PROPOSED TECHNICAL SPECIFICATION (TS) CHANGE

SEQUOYAH NUCLEAR PLANT UNITS 1 AND 2

DEPARTURE FROM NUCLEATE BOILING RATIO (DNBR) LIMITS BASES CHANGE

- 1) NUCLEAR PLANT(S): Sequoyah Units 1 and 2
- 2) SUBJECT (TITLE): Increased F Delta H from 1.55 to 1.62, Increased FQ From 2.32 to 2.4, With Mini RTDP
- 3) The written safety evaluation of the revised procedure, design change or modification required by 10CFR50.59(b) has been prepared to the extent required and is attached. If a safety evaluation is not required or is incomplete for any reason, explain on Page 2.

SEQUOYAH FINAL SAFETY ANALYSIS REPORT UNITS 1 and 2
Complete Loss of Forced Reactor Coolant Flow Heat Flux vs. Time (Hot Channel)
Figure 15.3.4-2c

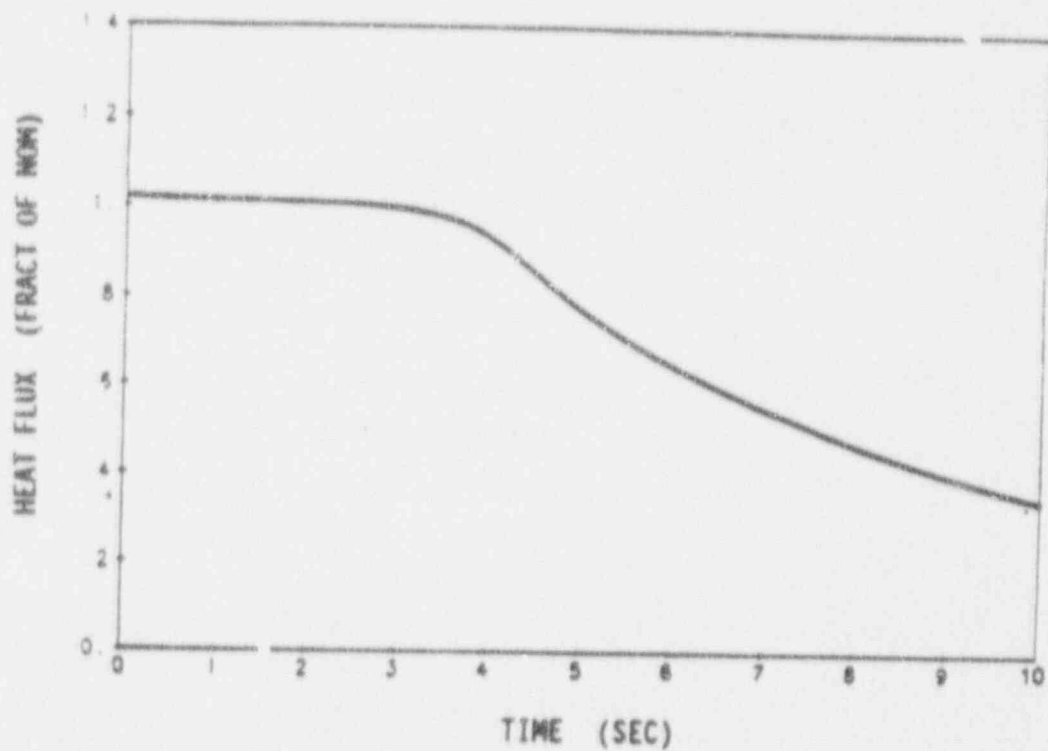
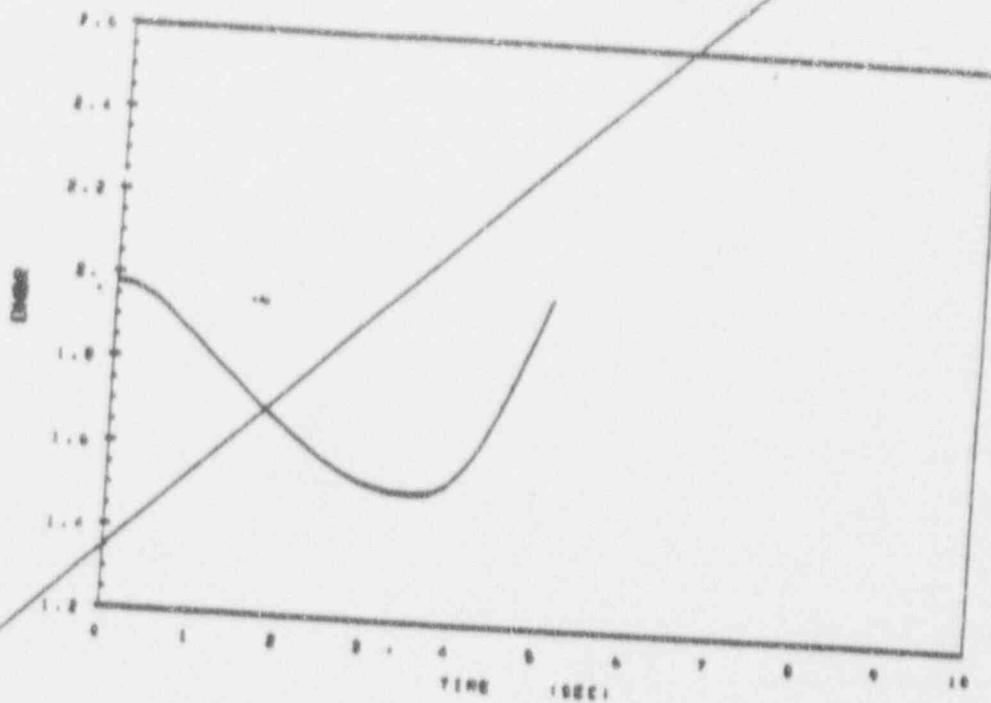
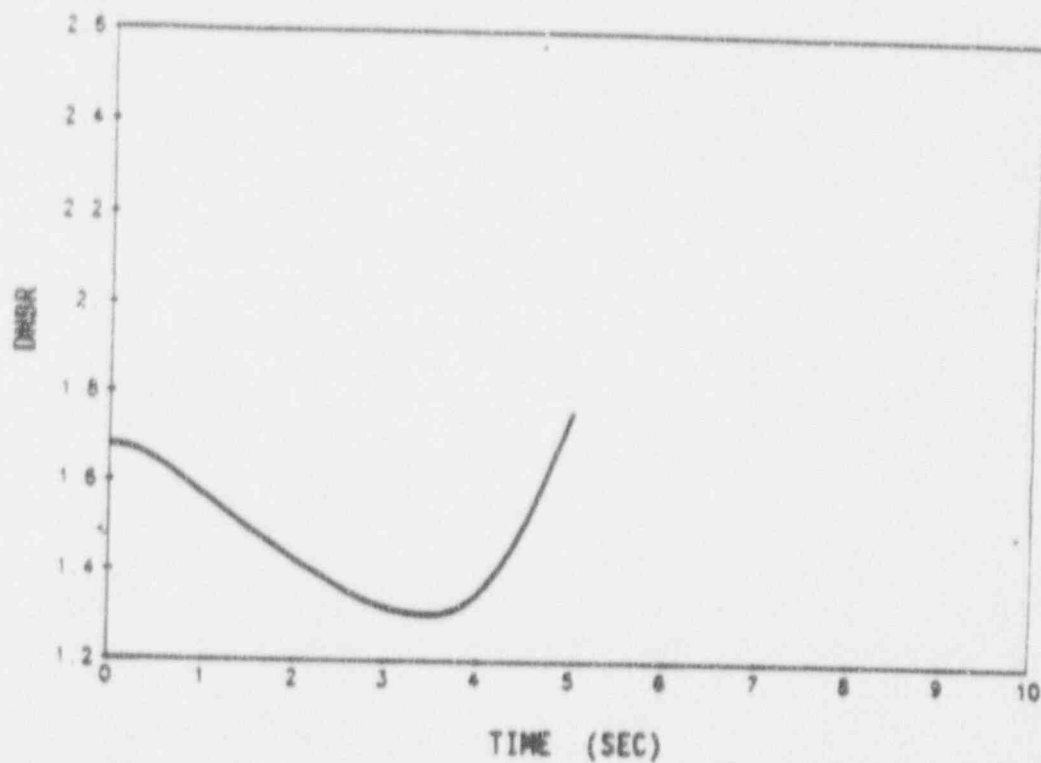
9.1.3 For the Complete Loss of Flow event the following changes were made: Text markups, Reference 8 updated, Table 15.3.4-1 revised, and Figures 15.3.4-1 through 15.3.4-3 were replaced.

REPLACE WITH THE FOLLOWING

<p>SEQUOYAH FINAL SAFETY ANALYSIS REPORT UNITS 1 and 2</p>
<p>Partial Loss of Forced Reactor Coolant Flow Reactor Vessel and Loop Flow vs. Time</p>
<p>Figure 15.2.5-1</p>

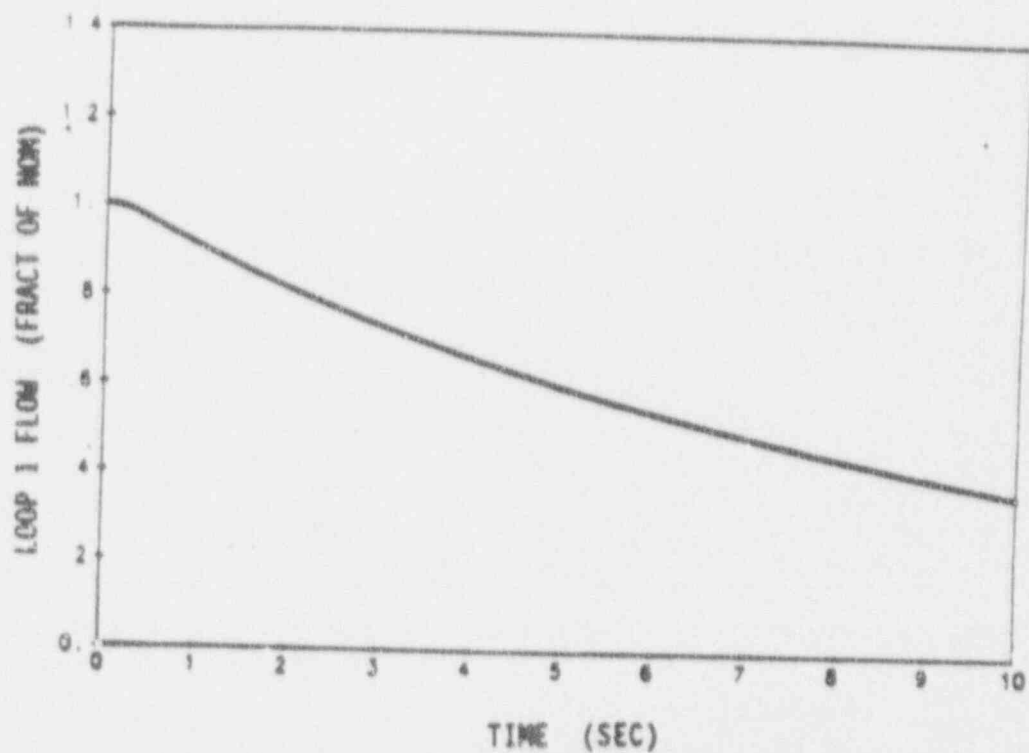
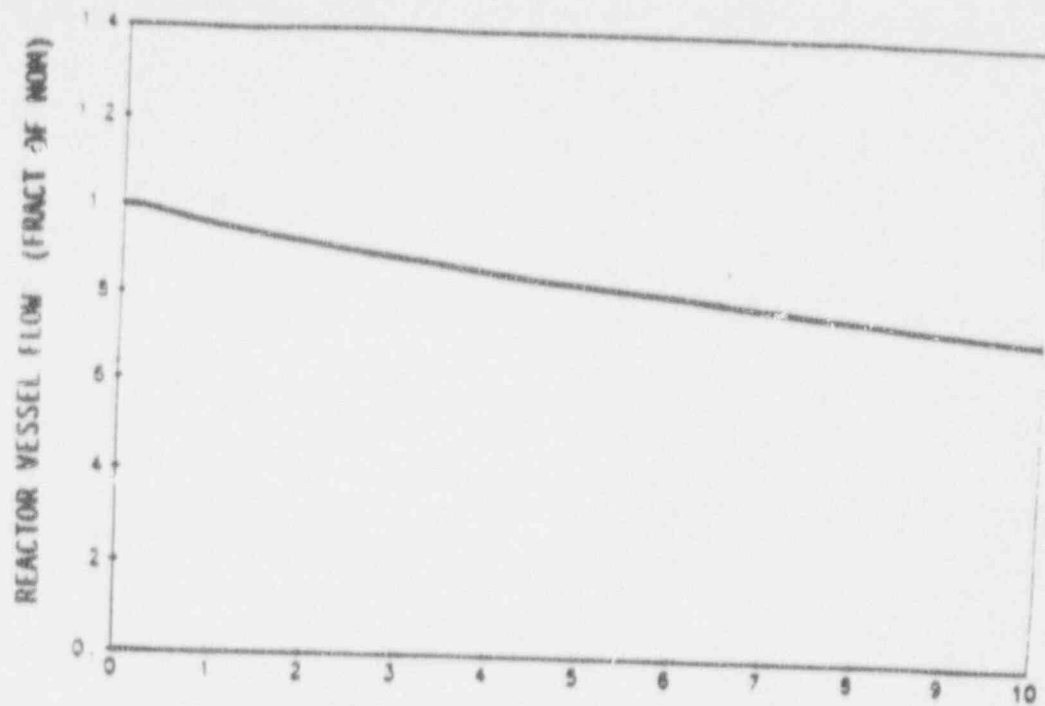
9.1.4 For the Partial Loss of Flow event the following changes were made: Text changes, Reference 3 update, Table 15.2-1 (sheet 2) revised, and Figures 15.2.5-1 through 15.2.5-3 were replaced.

REPLACE WITH THE FOLLOWING

Figures 15.2.5-1 through 15.2.5-3 show the resulting transient conditions for the 2/4 Partial Loss of Flow analysis. Included in these figures are total RCS flow, faulted loop flow, average and hot channel heat flux, nuclear power, and DNBR, each as a function of time.

SEQUOYAH FINAL SAFETY ANALYSIS REPORT UNITS 1 and 2
Partial Loss of Forced Reactor Coolant Flow Heat Flux vs. Time (Average Channel)
Figure 15.2.5-2b

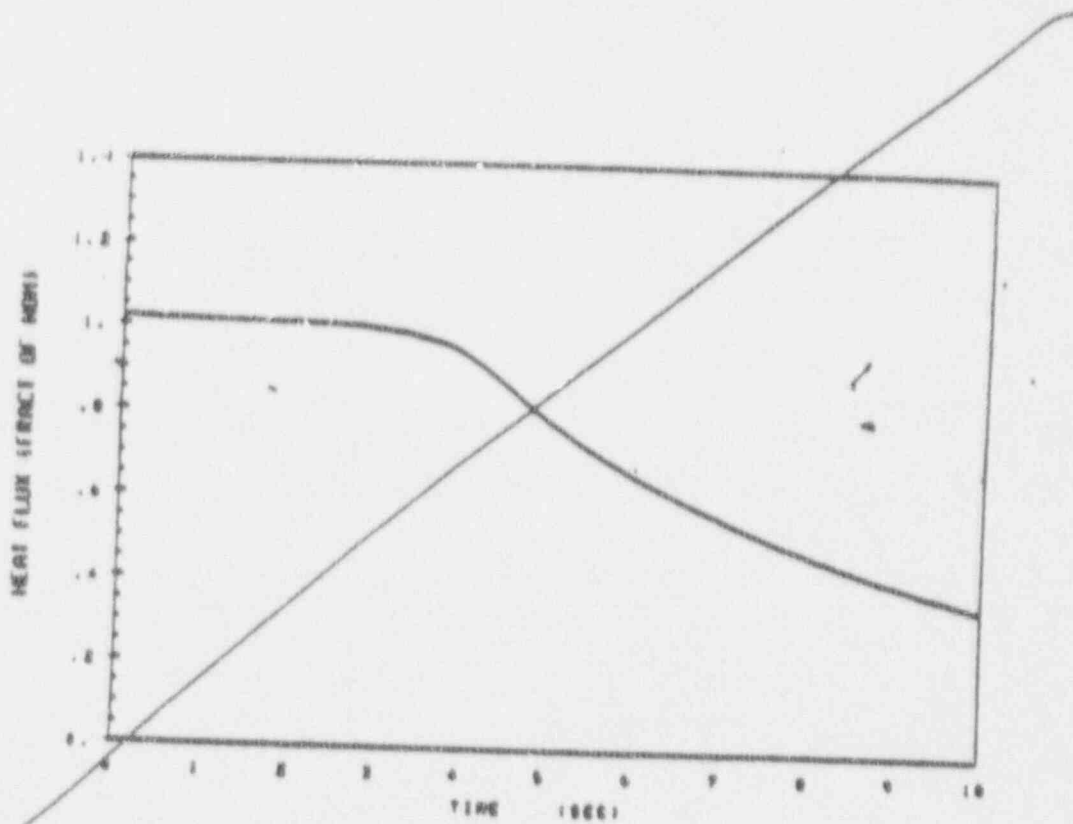
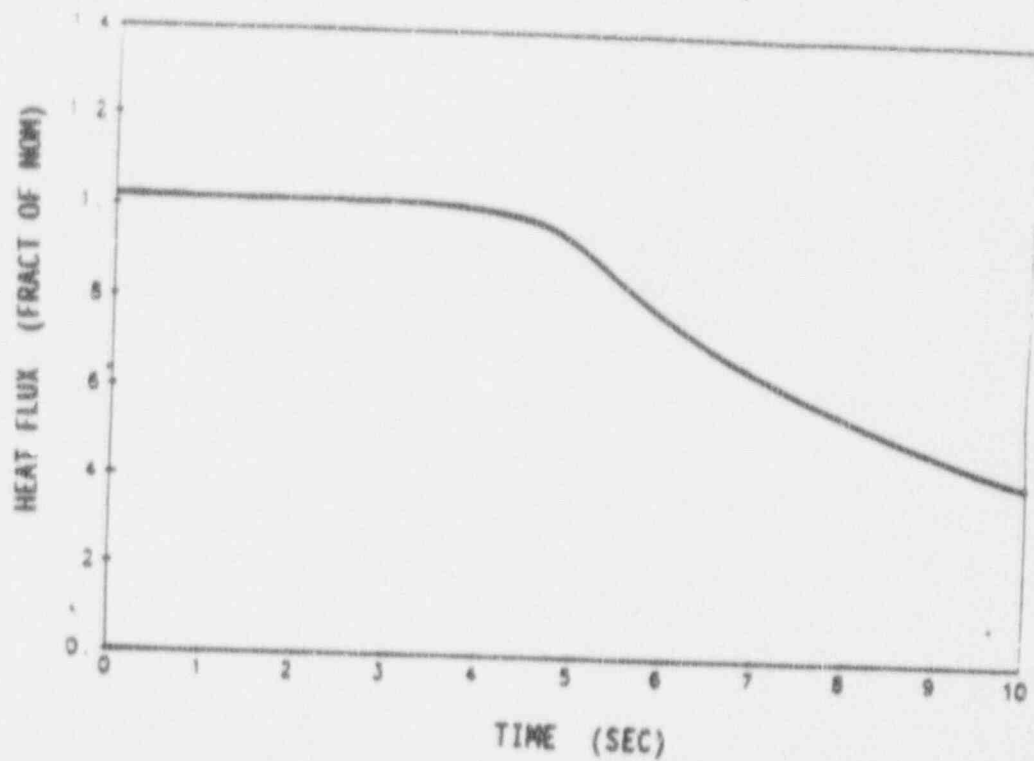
REPLACE WITH THE FOLLOWING

SEQUOYAH FINAL SAFETY ANALYSIS REPORT UNITS 1 and 2
Partial Loss of Forced Reactor Coolant Flow Nuclear Power vs. Time
Figure 15.2.5-2c

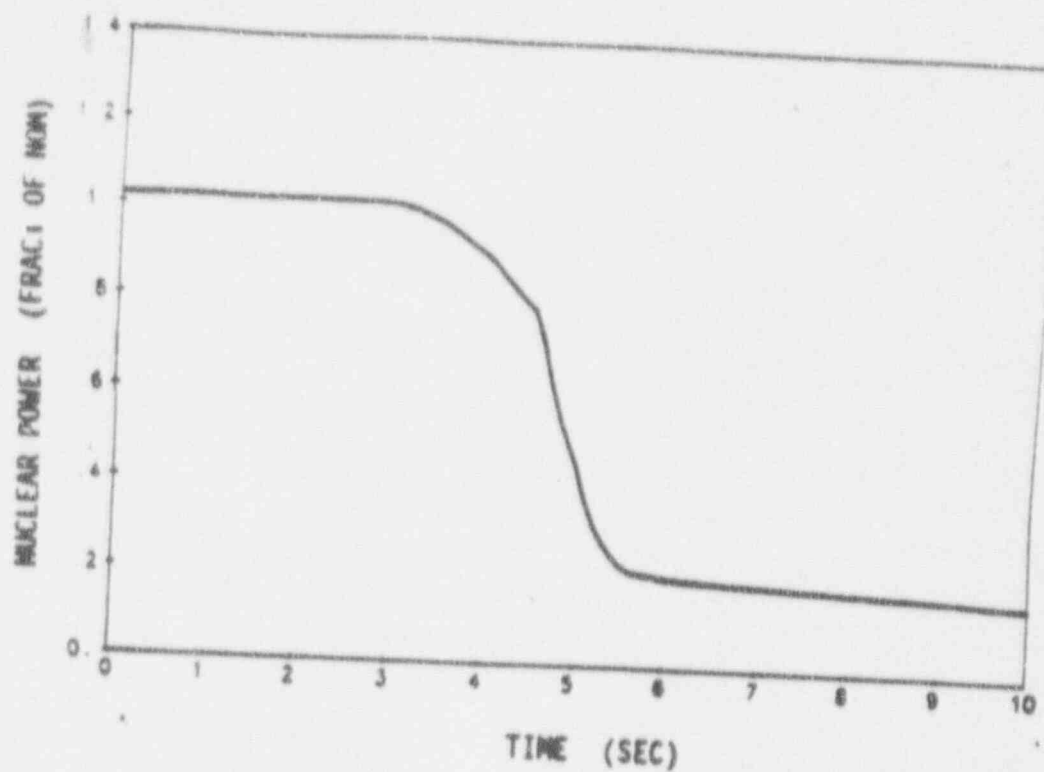
REPLACE WITH THE FOLLOWING

SEQUOYAH FINAL SAFETY ANALYSIS REPORT UNITS 1 and 2
Rod Cluster Control Assembly Ejection Nuclear Power vs. Time (EOL, HFP)
Figure 15.4.6-1

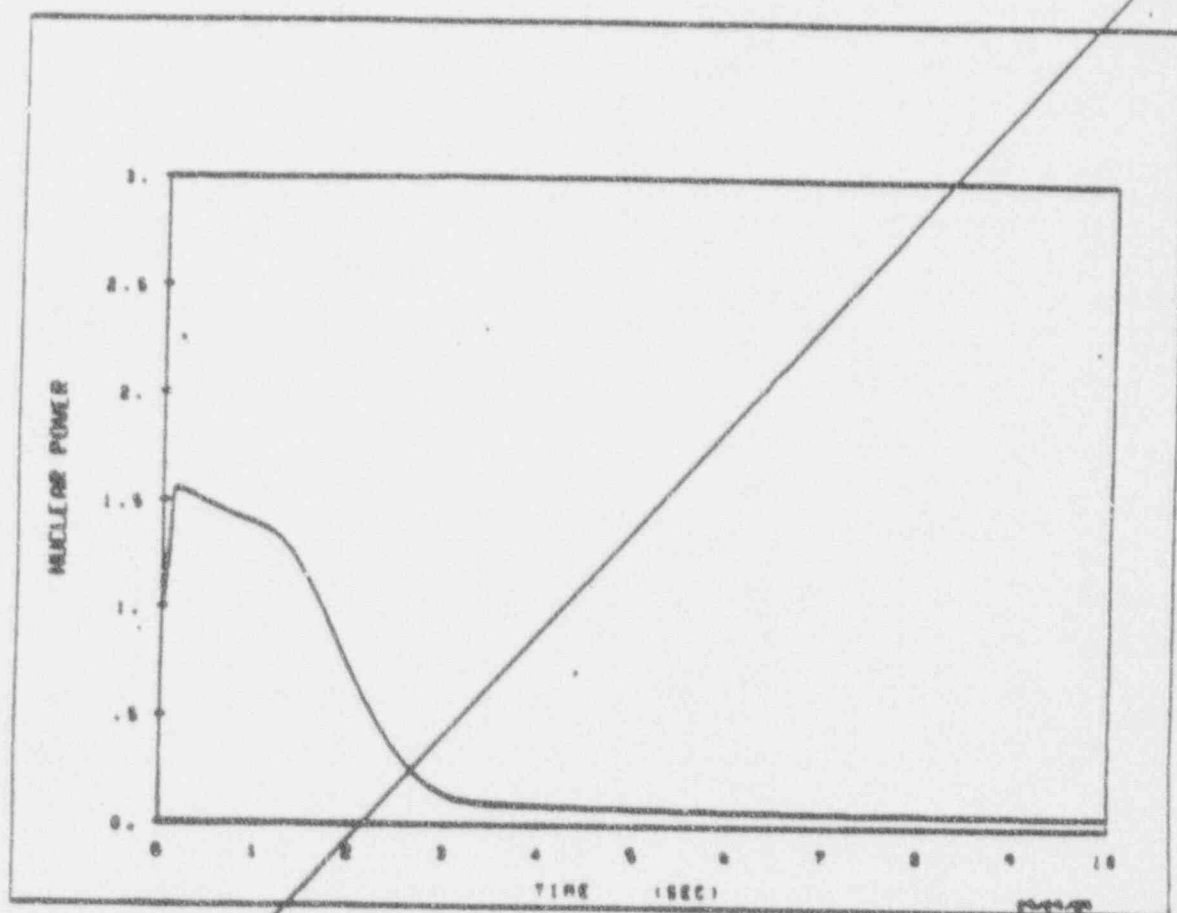
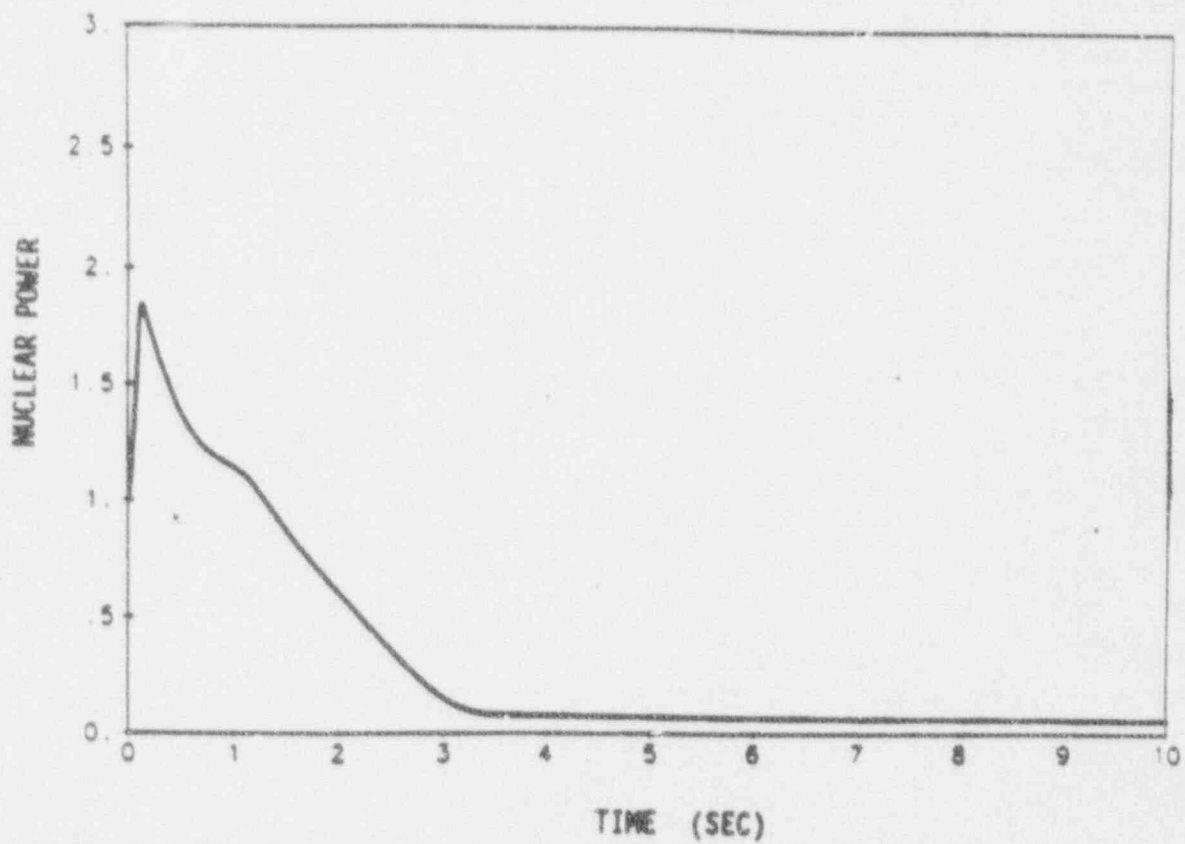
9.1.5 For the RCCA Ejection event the following changes were made: Text changes, References 25 and 29 updated, Tables 15.4.1-12 (sheet 3) and 15.4.6-1 were revised, and Figures 15.4.6-1 through 15.4.6-2 were replaced.

Replace with the following
